CITY OF WINTERS PLANNING COMMISSION AGENDA

PLANNING COMMISSION STAFF REPORT

SUBJECT: **Starbucks/Chevron/Fairfield Inn & Suites Tentative Parcel Map, Site Plan/Design Review/Sign Permit, Conditional Use Permit, and Rezone (Planned Development Overlay)**

FIGURE 5-2: CROSS SECTION OF COMPLETE STREET CONCEPT B (EAST MAIN STREET—I-505 INTERCHANGE)

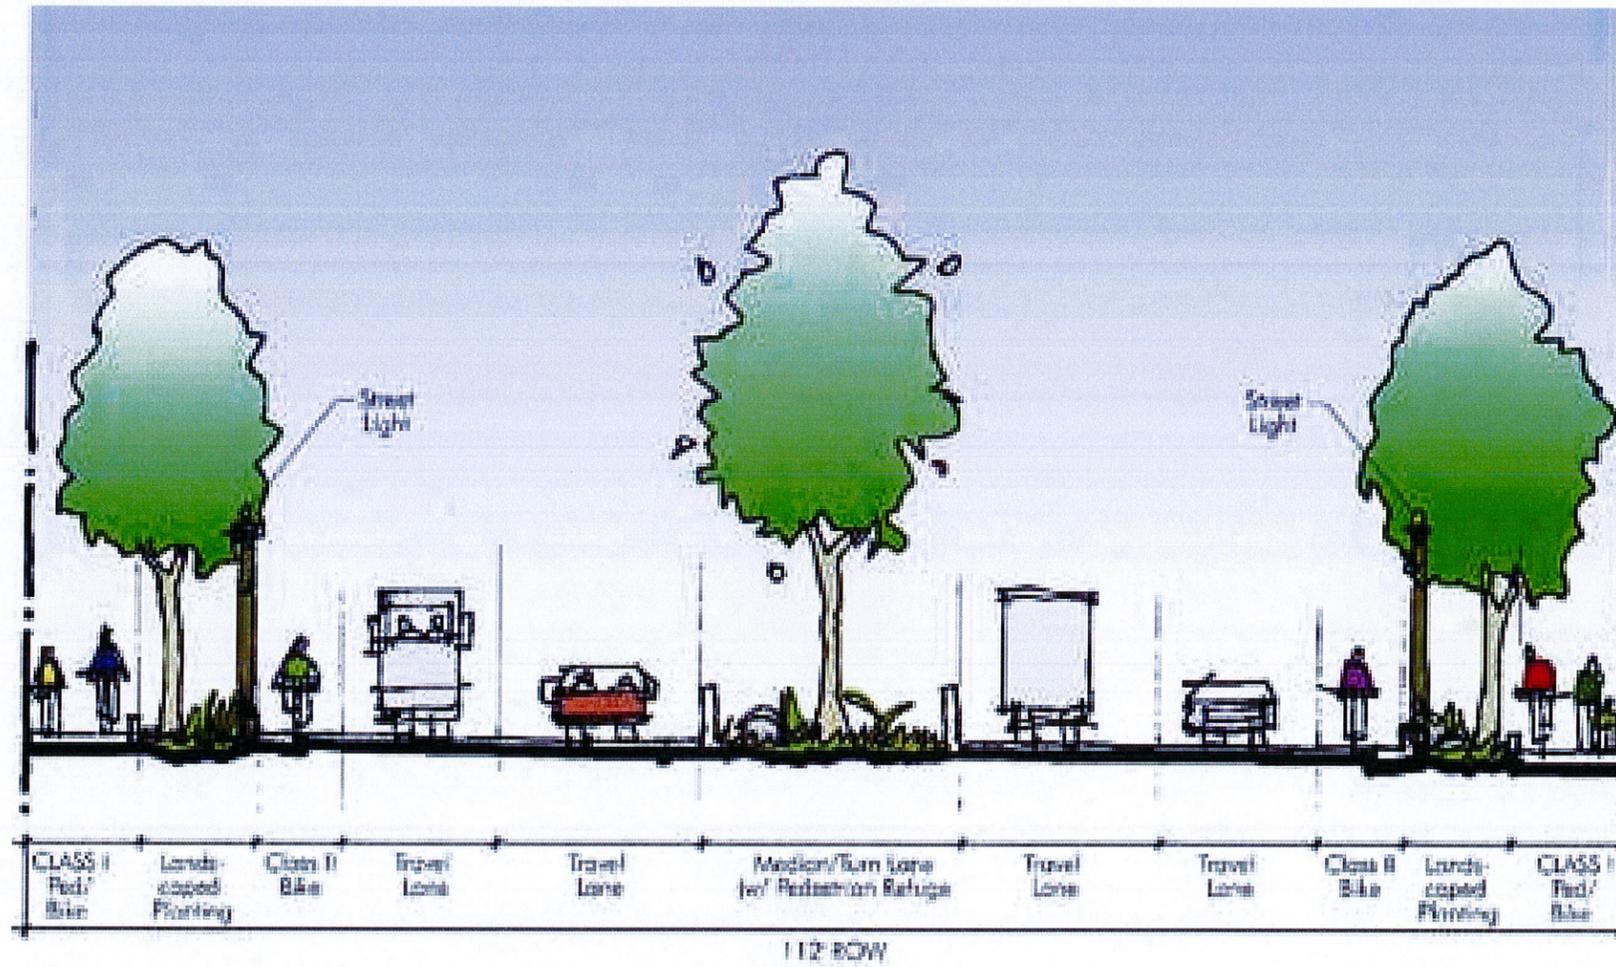
Curb, gutter, and sidewalk to City standards adhering to the Grant Avenue Design Guidelines will be constructed along the project frontage of Matsumoto Lane and Grant Avenue. There is a short section of sidewalk on Grant Avenue directly south of the fueling canopy that will remain monolithic (not separated) in order to accommodate the existing fueling canopy (not proposed to be moved), however the remainder of the proposed sidewalk will be of separated sidewalk adhering to the Complete Streets plan. The conditions of approval include these requirements.

59. Improvements to the East Grant Avenue frontage of the project shall be dimensionally consistent with the cross-section approved in the Complete Streets Concept Plan (Figure 5-2). Additional through lanes, curb and gutter, and raised medians are at the discretion of Caltrans.

PRELIMINARY SITE PLAN FOR
HOSPITALITY MANAGEMENT, INC.
 CITY OF WINTERS, CALIFORNIA

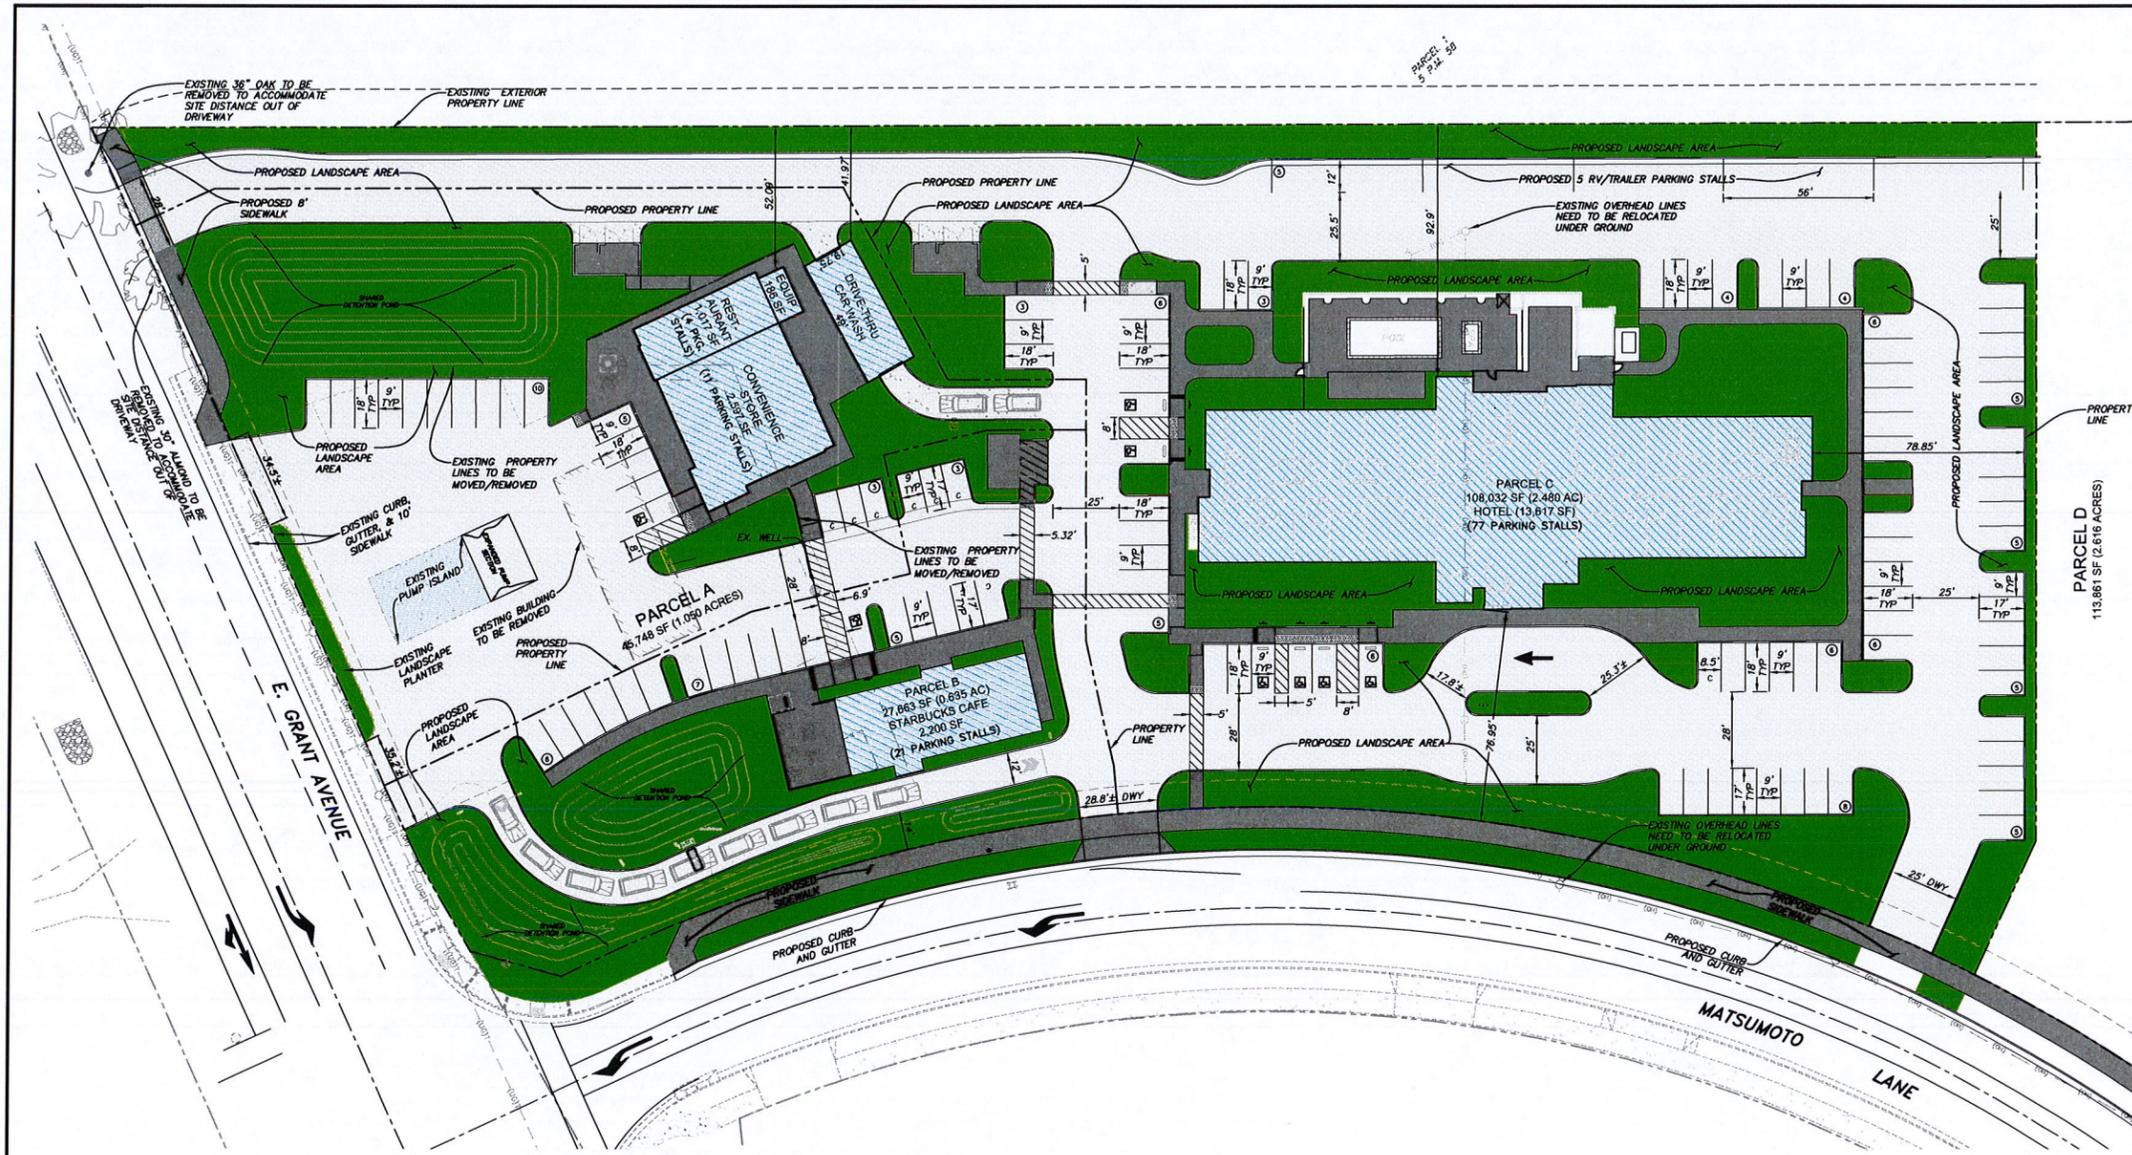
On the site plan the length of the parking spaces are either 17 feet for compact spaces or 18 feet for regular spaces. Assuming a two foot overhang, the length should be 16 feet for compact spaces and 17 feet for regular spaces. Landscaped areas or sidewalks area widths should be increased by one foot accordingly. The project is conditioned so that plans submitted for plan checking should show the correct length for compact and regular spaces.

Applicable City Standards address driveway separation along arterials and require a minimum separation of 150 feet. Staff is concerned with the potential for conflicts given the close proximity of the driveways. A condition has been added requiring the applicant to address this issue to the satisfaction of the City Engineer.

Currently there are above ground utilities fronting Matsumoto Lane and Grant Avenue and also bisecting the site. There are also two wells on the site. The Preliminary Site Plan shows the utility poles along Matsumoto Lane being removed and undergrounded and the two wells being abandoned. The applicant will need to get the appropriate approvals from PG&E, AT&T and any other utility that has lines on the utility poles before

5. On the site plan the parking spaces are either 17 feet long for compact spaces or 18 feet long for regular spaces. Assuming a two foot overhang, the length should be 16 feet for compact spaces and 17 feet for regular spaces. Landscaped areas or sidewalks area widths should be increased by one foot accordingly. Plans submitted for plan checking shall show the correct length for compact and regular spaces.
6. The design of the mural shall be conceptually approved by the Planning Commission. The final design of the mural to be approved by the Community Development Department prior to issuance of a building permit.
7. The proposed plans for the Chevron expansion and remodel assume the existing pumps are not being moved, relocated or replaced. If the pumps are moved, relocated or

53. A preliminary site plan showing ingress/egress for Matsumoto and Grant Ave has been submitted but not approved by the City. The Applicant shall work with the City Engineer and Caltrans to develop appropriate ingress/egress for Matsumoto and Grant Avenue, to avoid potential conflicts and provide safe circulation. A joint access agreement shall be provided in a form suitable to the City Attorney providing access to the driveway at the western edge of the project site for future access by the Manas parcel to the west.

DRAWN	M + A
CHECKED	M + A
DATE	5-21-2016
SCALE	NOTED
JOB #	16-155
SHEET	DR3.1

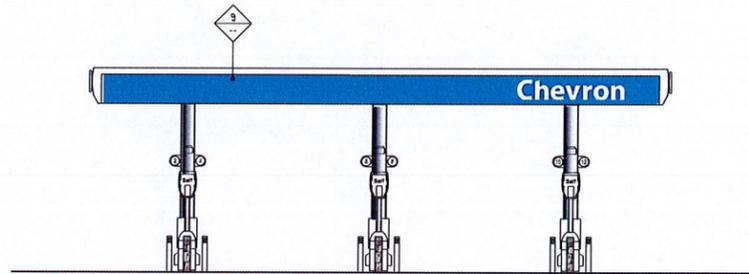
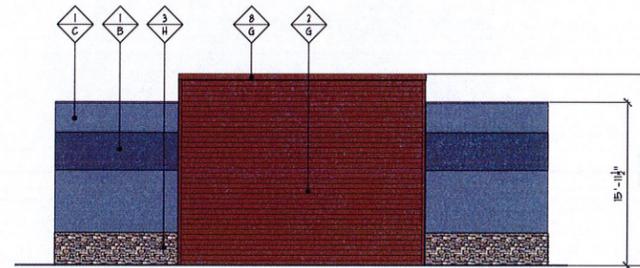
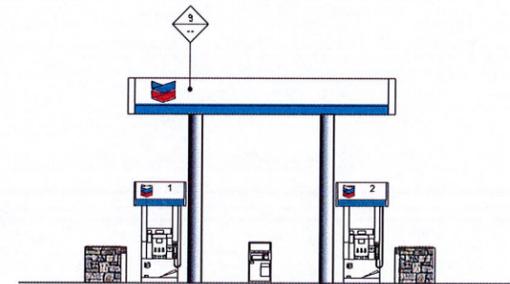
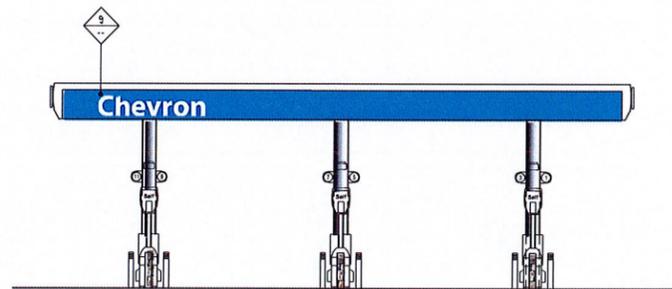
The plans for Chevron include expanding the pump islands and canopy by increasing the number of pumps from 4 to 6 and extending the fueling canopy. Staff recommended to the project architect that the columns for the fueling canopy, existing and proposed, be wrapped in the same ledgestone proposed as a wainscot for the new convenience store market. The architect indicated there is not any room between the existing columns and pumps to allow for wrapping. It is possible when the pump island is expanded the existing pumps may need to be moved or replaced. If they are moved or replaced staff has conditioned the project so that the existing and new columns be wrapped in ledgestone.
